ACCESSION NBR: 8109110415 DOC. DATE: 81/09/04 NOTARIZED: NO DOCKET: #
 FACIL: 50-397 WPPSS Nuclear Project, Unit 2, Washington Public Power 05000397
 AUTH. NAME: AUTHOR AFFILIATION
 BOUCHEY, G.D. Washington Public Power Supply System
 RECIP. NAME: RECIPIENT AFFILIATION
 SCHWENCER, A. Licensing Branch 2

SUBJECT: Forwards responses to Containment Sys Branch 810316 request
 for addl info. Responses will be incorporated into FSAR amend
 within 4 months. Remainder of responses re hydrogen
 recombiner will be submitted to NRC by 810918.

Subject: SUPPLY SYSTEM NUCLEAR PROJECT NO. 2
RESPONSES TO CONTAINMENT SYSTEMS
BRANCH QUESTIONS

Reference: Letter, RL Tedesco to RL Ferguson, "Request for Additional Information Regarding the WNP-2 Facility (CSB)" dated March 16, 1981.

FIGURE 5.2-10
9H.114-2

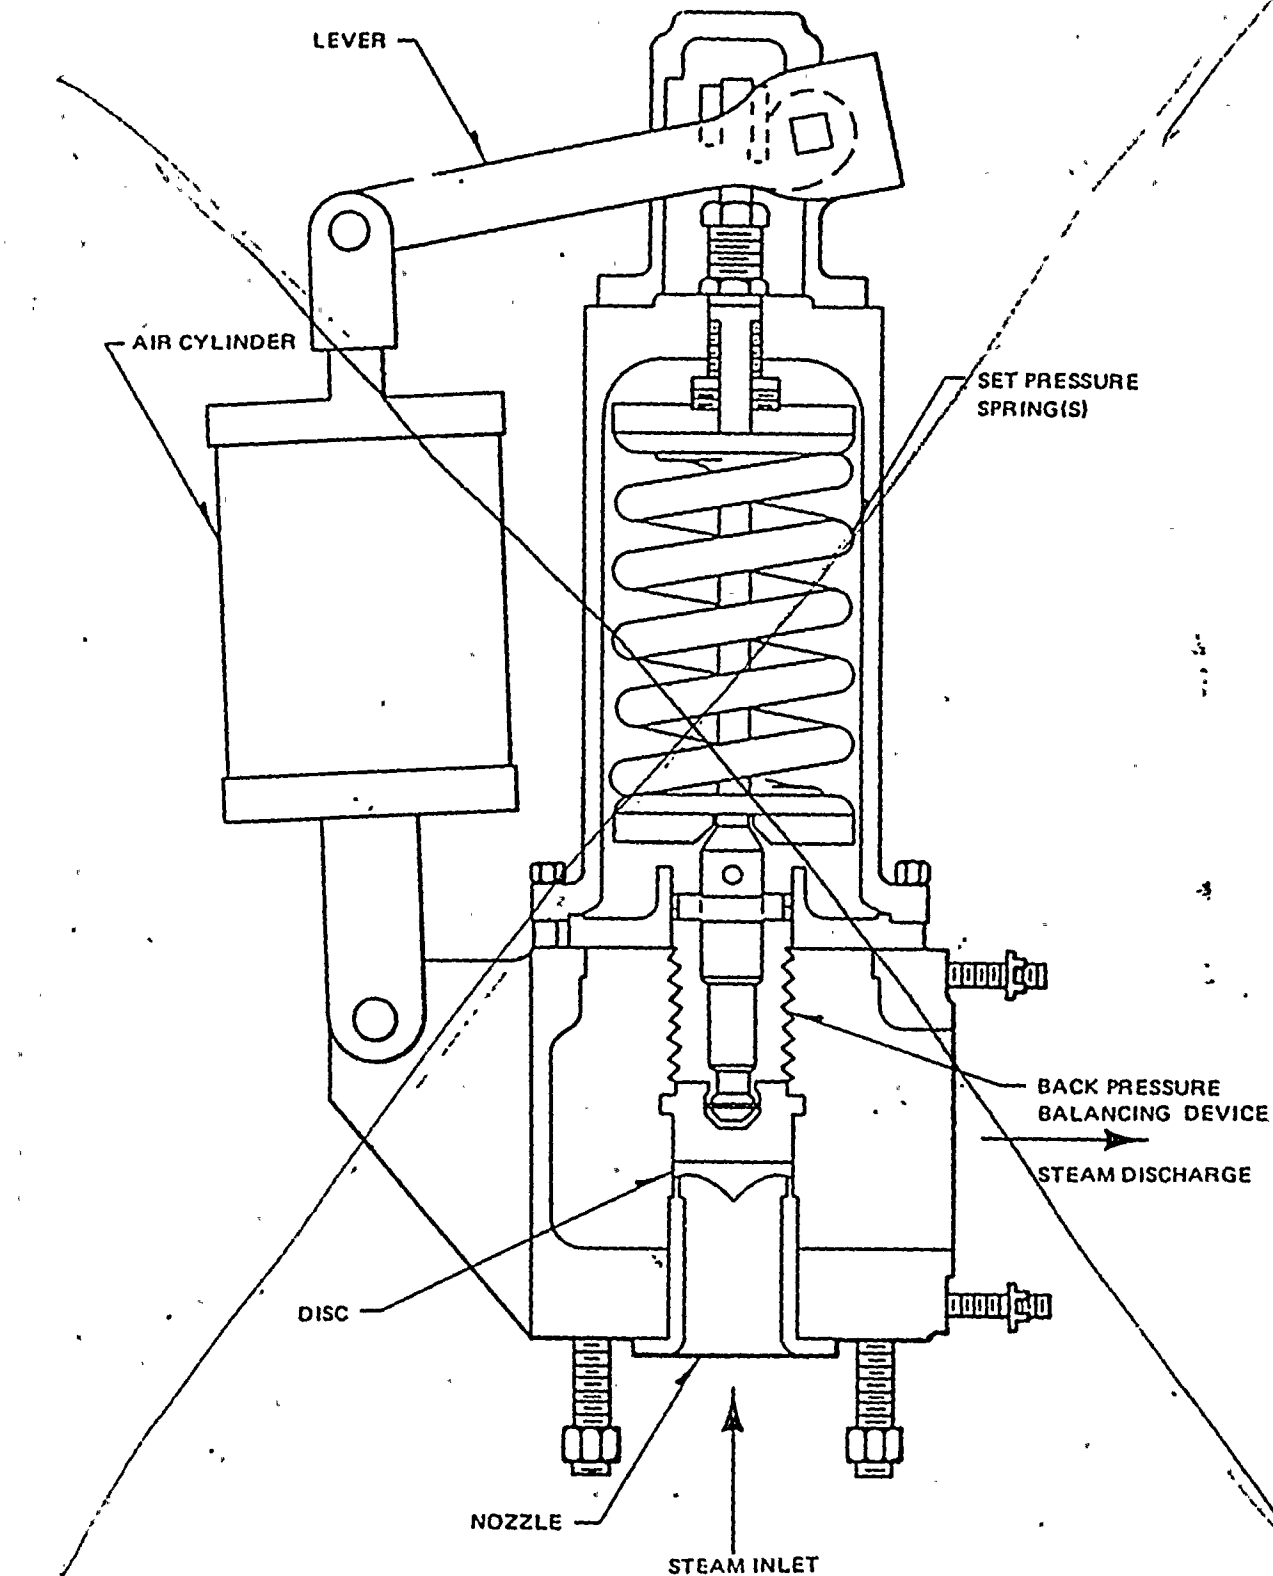
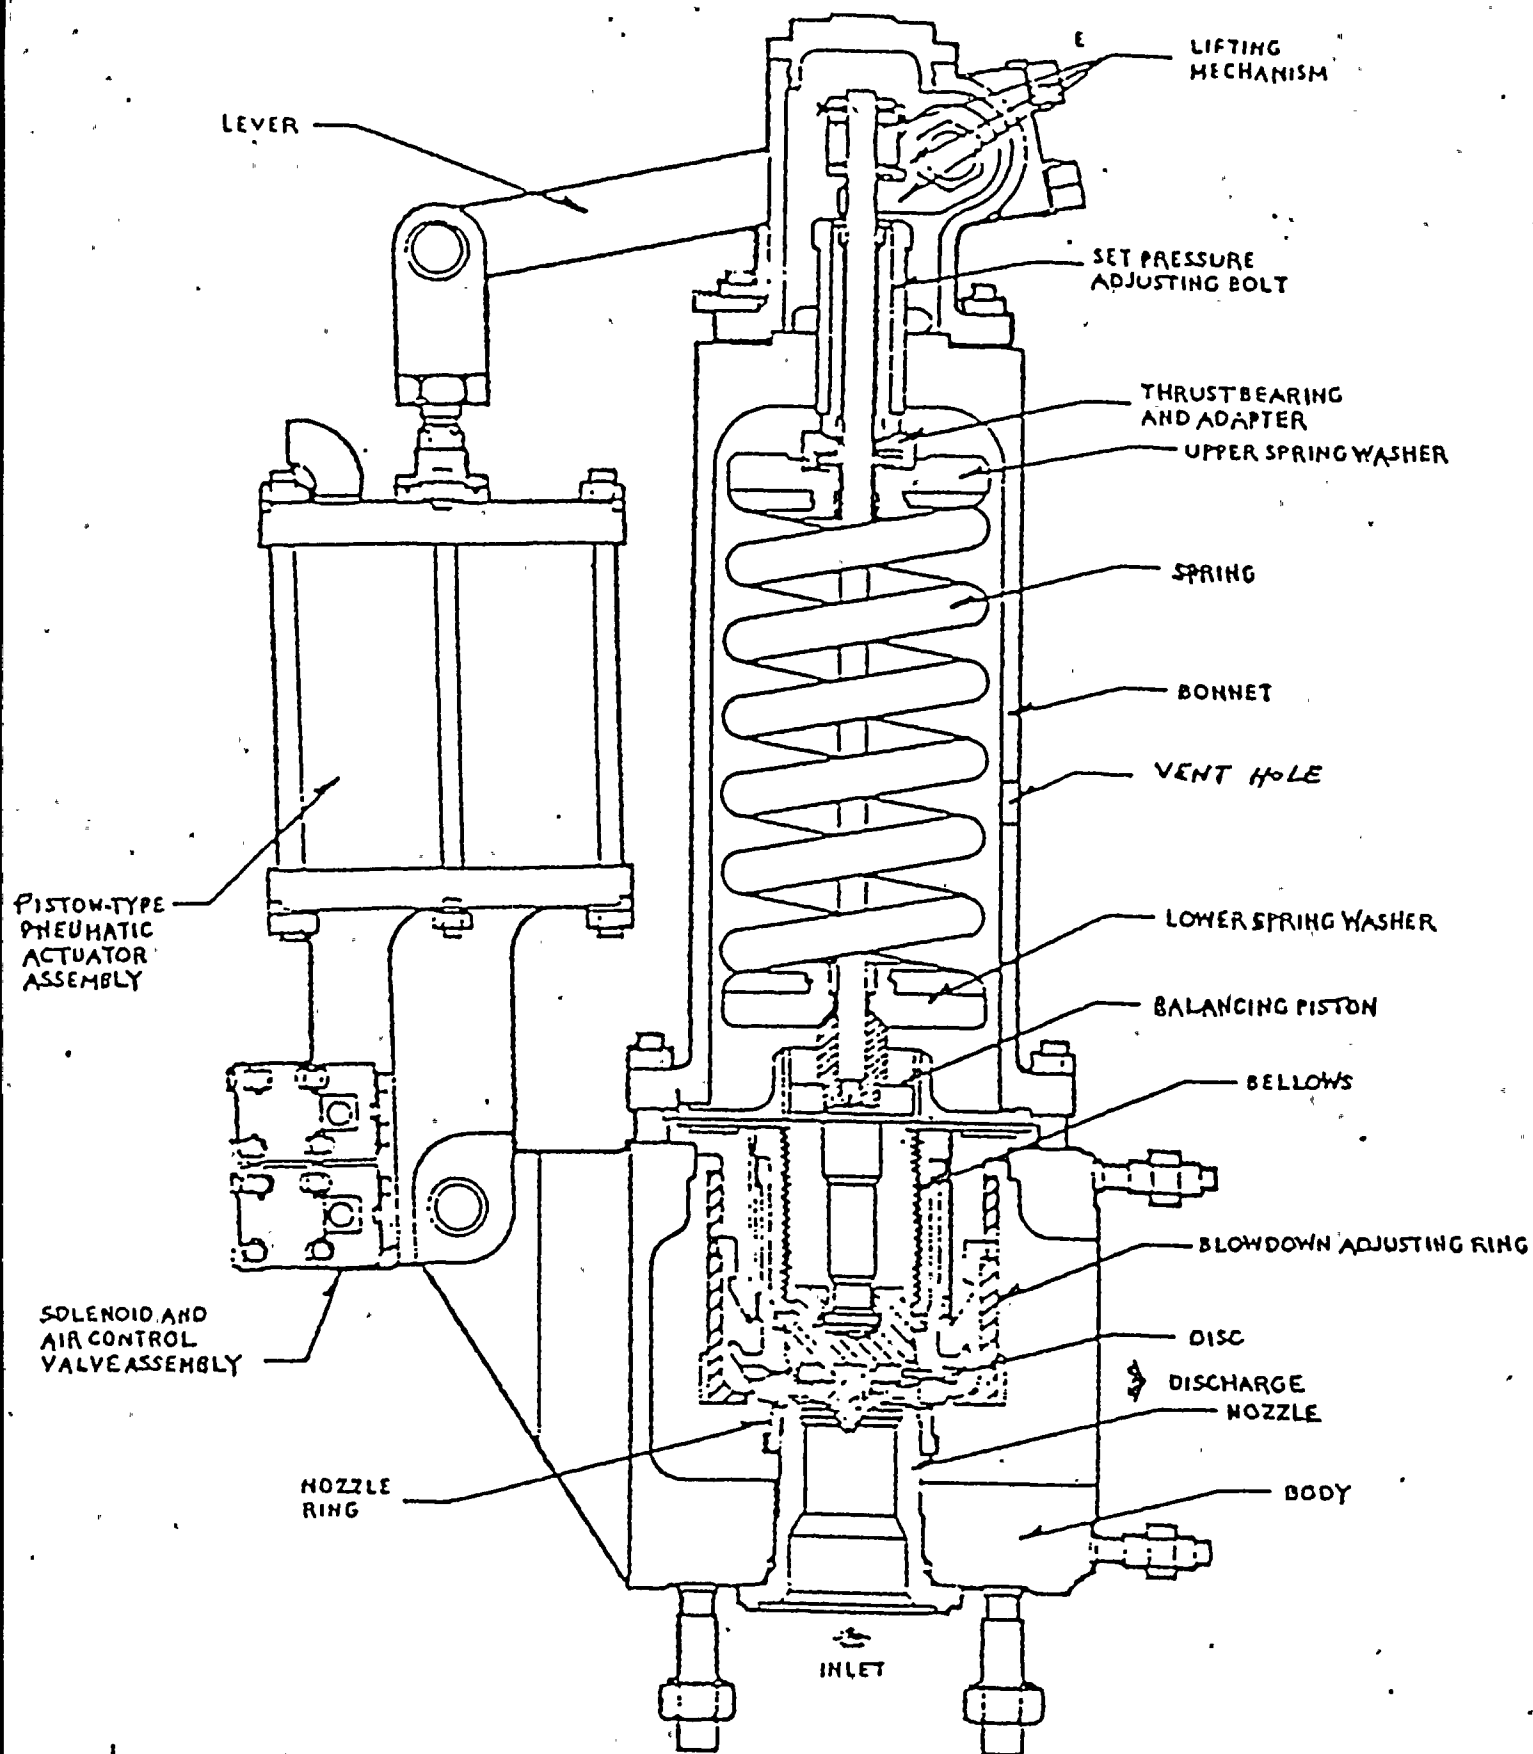
Subsection 5.2.2.4.1 of the FSAR states that each Safety/Relief Valve is provided with a device to counteract the effects of backpressure which results in the discharge line when the valve is open and discharging steam. What type of device is provided? Describe the device and what effects would be anticipated if the device were to fail.

There is not a singular backpressure balancing device, but there is an integrated feature in each Safety/Relief Valve to counteract the effects of backpressure when the valve is open and discharging steam. To prevent this backpressure from affecting the valve's spring lift set point, each valve has a bellows and a balancing piston. The bellows isolates steam in the valve discharge chamber from the valves's internals, and prevents discharging steam from affecting the valve's set point. If the bellows fails, the balancing piston serves as a functional back-up by presenting an effective piston area to the back pressure equal to the valve seat area. This reduces the acting spring load on the disc insert by the amount of back pressure load additive to the spring set pressure load acting on the disc holder, thus balancing (neutralizing) it so that there is no net back pressure effect on the set (popping) point.

FSAR Figure 5.2-10 has been revised to show the bellows and balancing piston, and the FSAR text in Subsection 5.2.2.4.1 has been revised to include a reference to the bellows and balancing piston arrangement.*

To prevent backpressure from affecting the spring lift setpoint, each valve is provided with a ~~device~~ ^{a bellows and balancing piston} to counteract the effects of backpressure which results in the discharge line when the valve is open and discharging steam.

The bellows isolates steam in the valve discharge chamber from the valve's internals. If the bellows fails, the balancing piston serves as a functional back-up by presenting an effective piston area to the back pressure equal to the valve seat area. This reduces the acting spring load on the disc insert by the amount of back pressure load additive to the spring set pressure load acting on the disc holder, thus

FIGURE
15.0-2

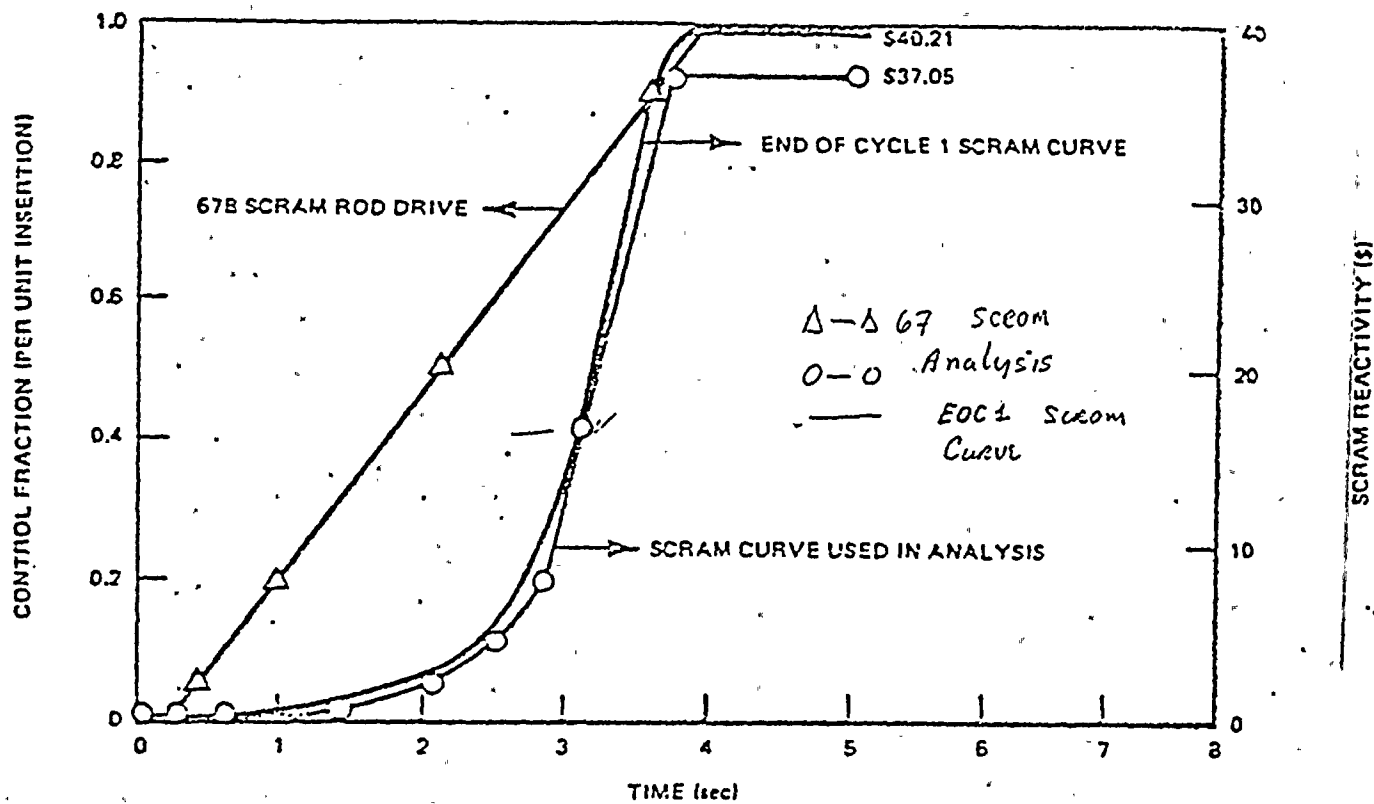
In relation to Figure 15.0-2, confirm the following items for all transients in Chapter 15.0 which require control rod insertion to prevent or lessen plant damage.

- a) The scram curve used in Chapter 15.0 analyses (Figure 15.0-2) has a total reactivity worth of \$37.05 and is the nominal conservatism factor of 0.8.
- b) The slowest allowable scram insertion speed was for the scram curve applied to Chapter 15.0 analyses.
- c) The end of cycle 1 scram curve has a total reactivity worth of \$40.21 and is identified incorrectly in Figure 15.0-2.

- a) The scram curve used in Chapter 15.0 analyses with a total reactivity worth of \$37.05 is quite conservative compared to the nominal scram curve. For any transient, since the neutron flux would drop significantly within 2 to 3 seconds after scram, the excess negative reactivity introduced after this short period of time has negligible effect on the peak values of the important parameters, e.g., neutron flux, surface heat flux or vessel pressure. The initial portion of the scram curve used for analyses bounds the nominal scram curve multiplied by the conservatism factor of 0.8 in order to assure the coverage of the transient effect with the intended conservatism.

- b) The scram time characteristic shown in Figure 15.0-2 is derived from the Technical Specification scram time. The slowest allowable scram insertion speed was used for the scram curve applied to Chapter 15.0 analyses.

- c) The \$40.21 is the correct total reactivity worth for the end of cycle 1 scram curve and is incorrectly labeled in Figure 15.0-2. Figure 15.0-2 has been corrected.*
